RANDOX
Urgent Field Safety Notice

Complaint Reference: REC473 **REV 2**

Action Type: Device Modification

Fig. 1 Patient correlation using original assigned calibrator values and realigned calibrator values on Siemens ADVIA 1800

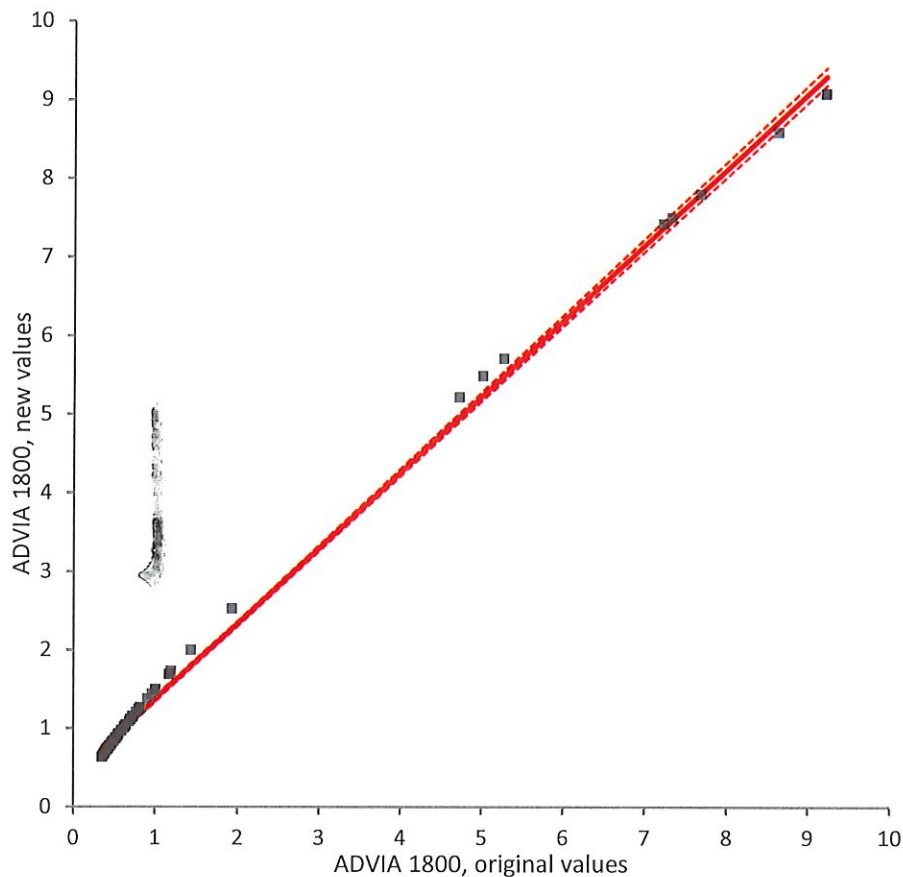
Randox have reviewed the standardisation for Soluble Transferrin Receptor (sTfR) as per the labelling claim and have realigned the sTfR Immunoturbidimetric method to the WHO reference material NIBSC code 07/202. As a result the Calibrator and Control batches listed in the table above have been reassigned. Patient values will increase with the new calibrator values and the shift is more pronounced within the normal range (0.65mg/L to 1.88mg/L). See patient correlation below (Fig. 1).

- Refer to the attached IFUs for updated calibrator values and control targets and ranges. These can also be found on www.randox.com.
